WESTERN PLYMOUTH NEIGHBORHOOD ALLIANCE INFORMATION REQUEST

Applicants Xcel Energy and Great River Energy

Docket No.: PUC E-002/TL-11-152
OAH 8-2500-22806-2

Response To: Western Plymouth Neighborhood Alliance Information Request No. 5

FLOODPLAIN CROSSING LENGTHS ALONG PORTIONS OF THE PROPOSED ROUTE
Hollydale Project

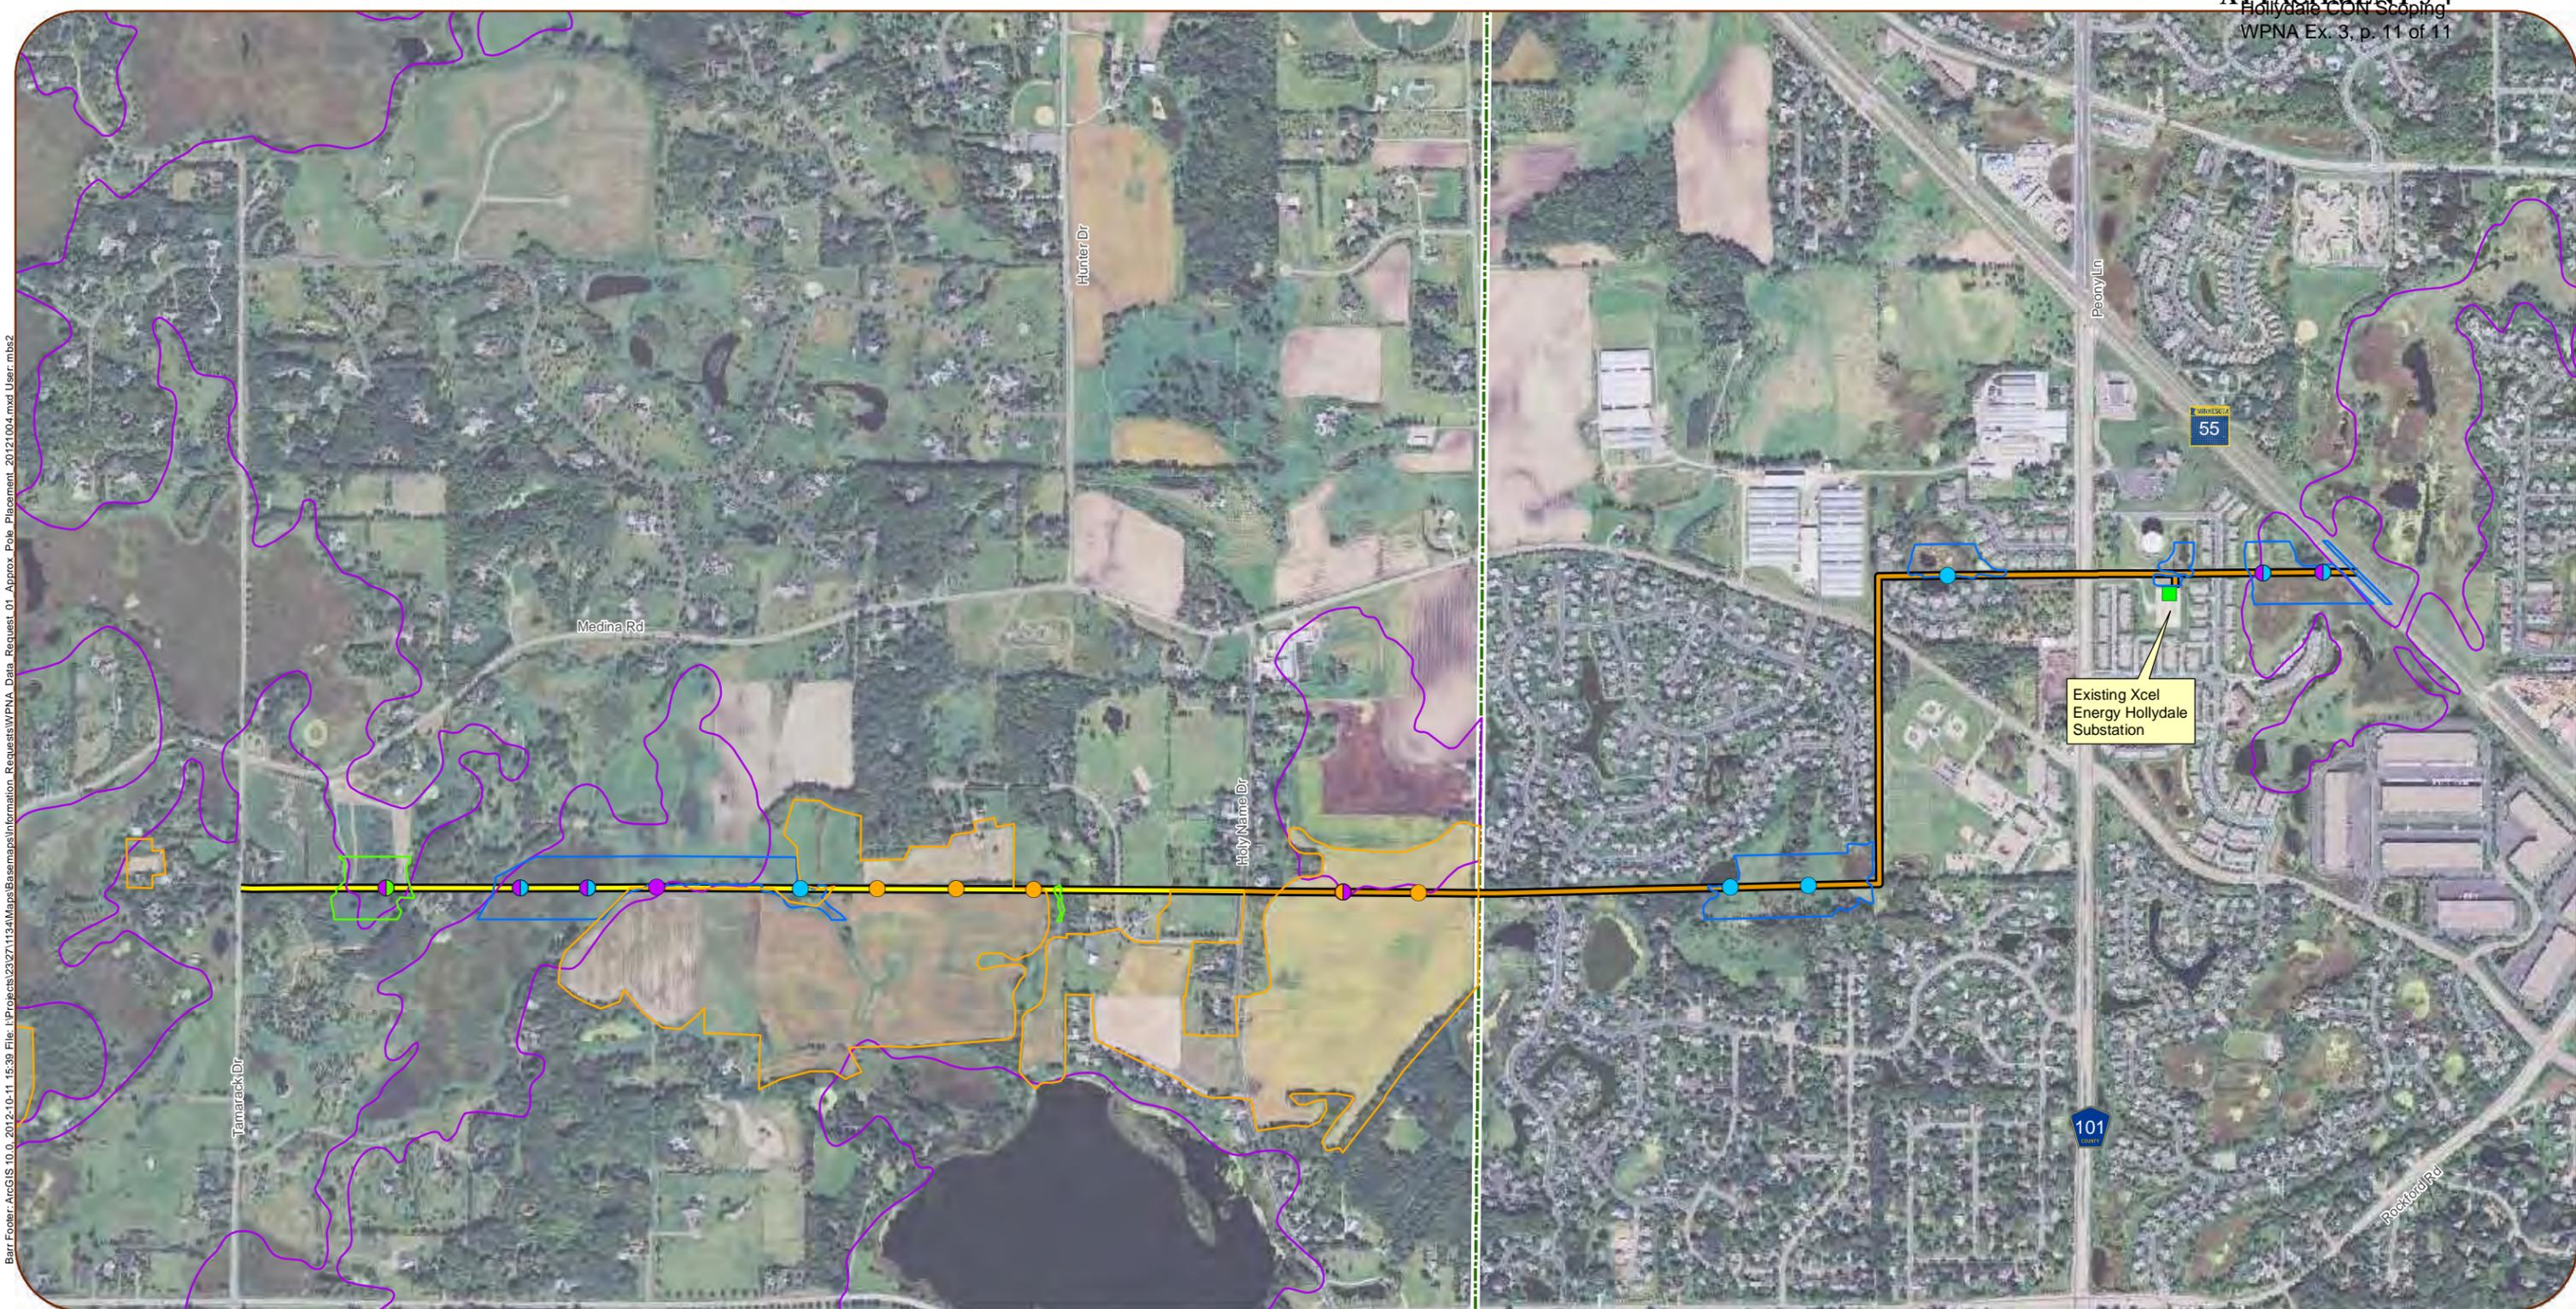
1. Describe in narrative or identify on a map with appropriate notations each wetland and floodplain within the Proposed Route right-of-way with a span to be crossed of a) from 100 to 300 feet; b) from 300 to 500 feet; c) from 500 to 1,000 feet; d) more than 1,000 feet.

a. See **Attachment 5-3**.

APPROXIMATE POLE PLACEMENT
 IN RELATION TO WETLANDS,
 FLOODPLAINS, MATURE TREES, AND
 AGRICULTURAL CROP LANDS
 Hollydale Project

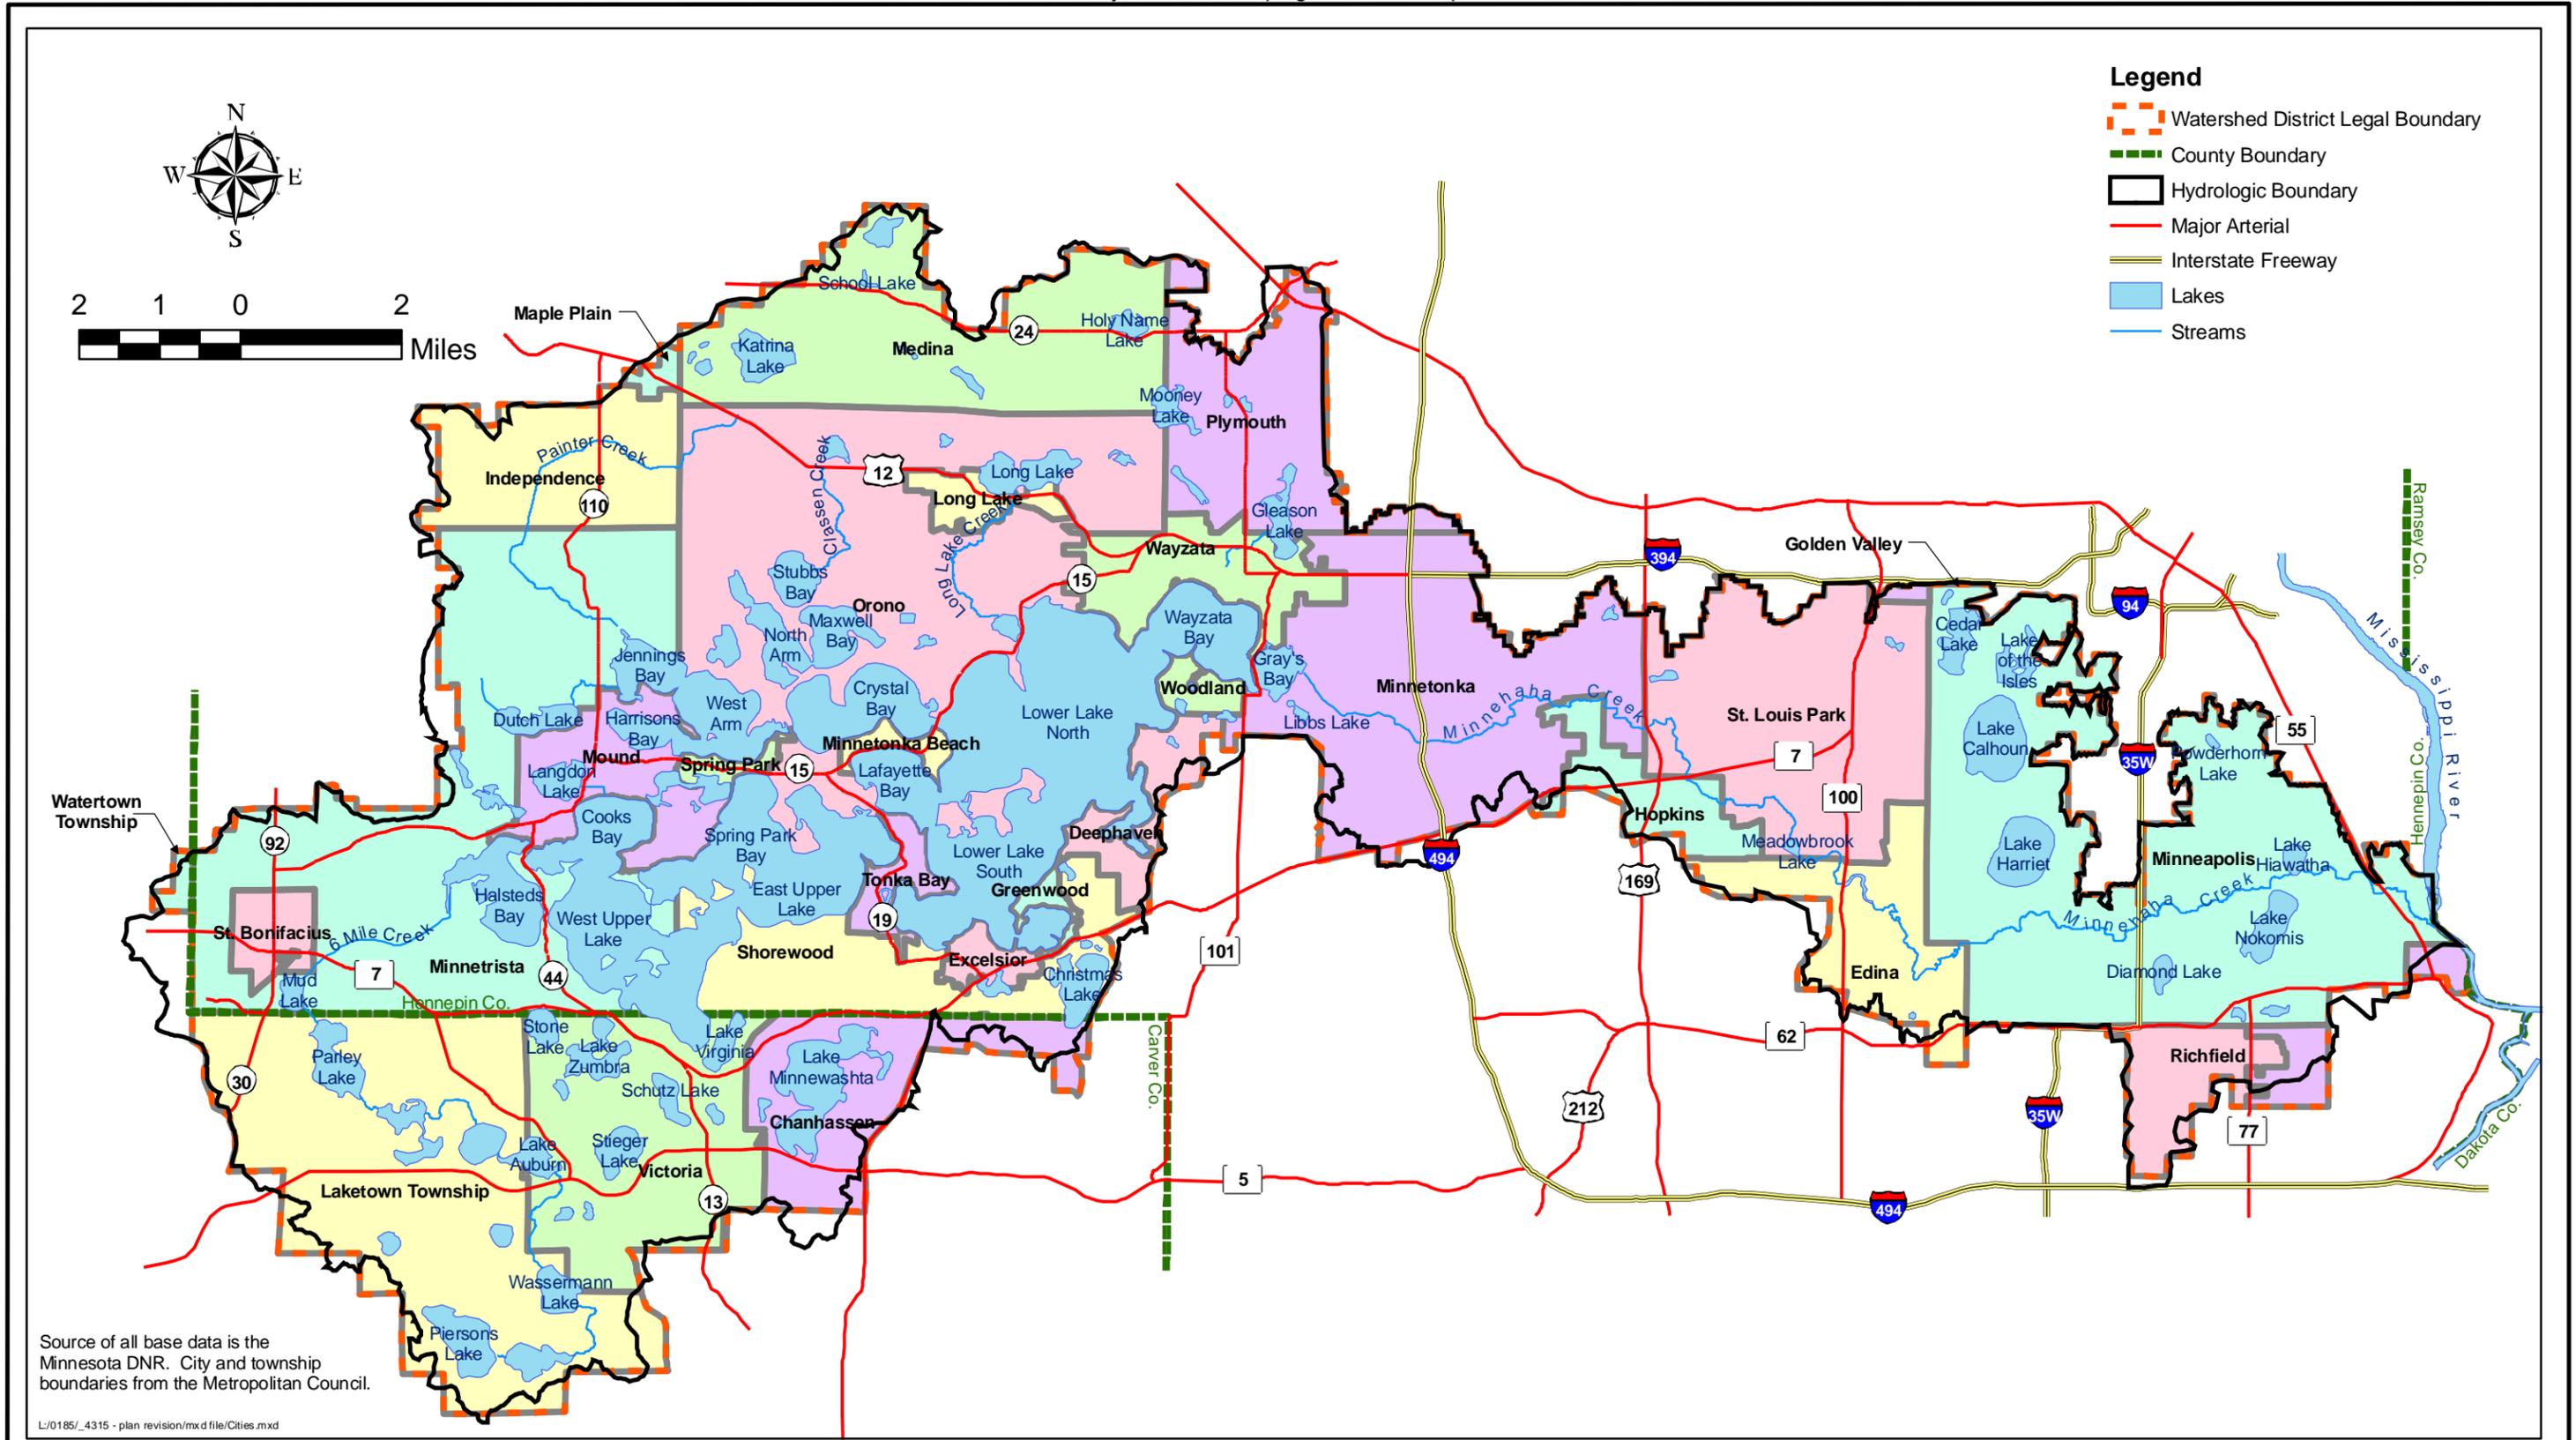
3. Please state the number of structures estimated to be constructed on a) wetlands; b) wooded wetlands; c) floodplains; d) areas containing mature trees; and e) agricultural crop lands in the above-described segments of the Proposed Route.

4. Please provide a map identifying approximate locations of any structures identified in subparagraph (3) above.
 - a. See **Attachment 5-4**.

a. At this time, Applicants anticipate replacing structures in wetlands and/or floodplains at or near existing pole locations; these locations would not require the use of Y-frame structures.

Proposed Route from the intersection of the Proposed Route with Highway 55 west to the intersection of the Proposed Route with Holy Name Drive	
Land Type	Poles
Wetland	5
Woody Wetland	0
FEMA Floodplain	3
Cropland	2
Forest	0
Total Poles*	7
*Some poles fall into more than one category. Refer to map.

Proposed Route from the intersection of the Proposed Route with Holy Name Drive west to the intersection of the Proposed Route with Tamarack Drive	
Land Type	Poles
Wetland	3
Woody Wetland	1
FEMA Floodplain	4

Cropland	3
Forest	0
Total Poles*	8
*Some poles fall into more than one category. Refer to map.
